21-COA-0064
1267 Willow Ave.

Cherokee Triangle Architectural Review Committee
Public Hearing

Kat Groskreutz, Historic Preservation Specialist
April 7, 2021

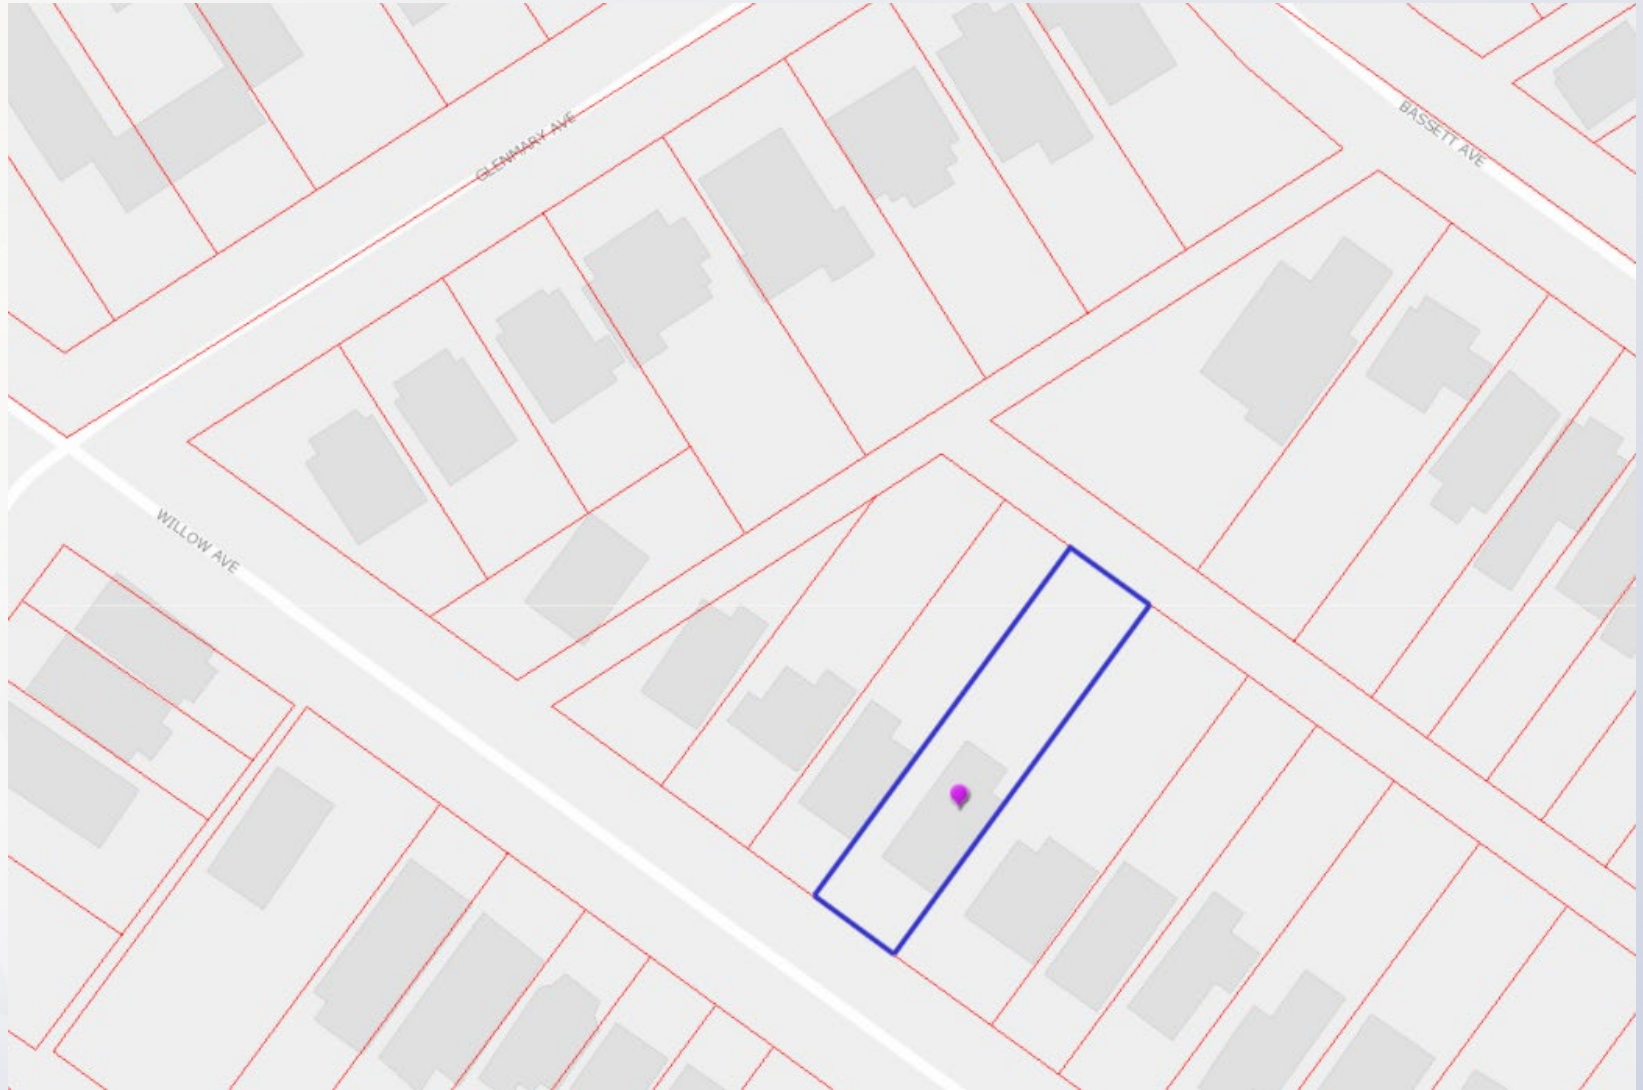
- Staff conducted a site visit on March 12 to assess the windows
- Staff determined most of the windows could be approved for replacement at a staff level by meeting W1 or being prior replacements
- Both first floor front façade windows and the large, right-hand window on the second floor were determined to not meet W1 and were requested to be filed as a separate application request for ARC

Site Photos

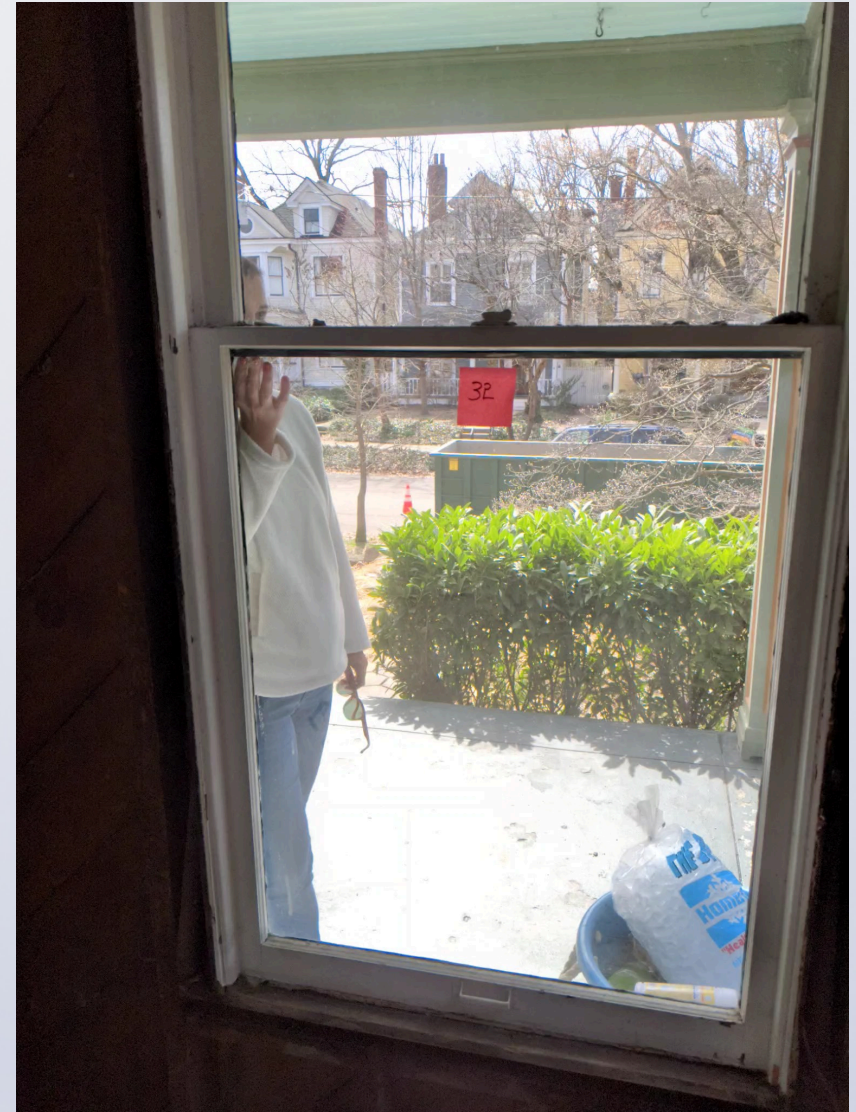
- The sashes and sills do not appear to be severely deteriorated
- There is evidence of prior poorer quality repair attempts on the sashes
- Some of the larger panes of glass are cracked which may make retention of the glass difficult
- They are currently non-operational, but Staff observed the sash weights were still present
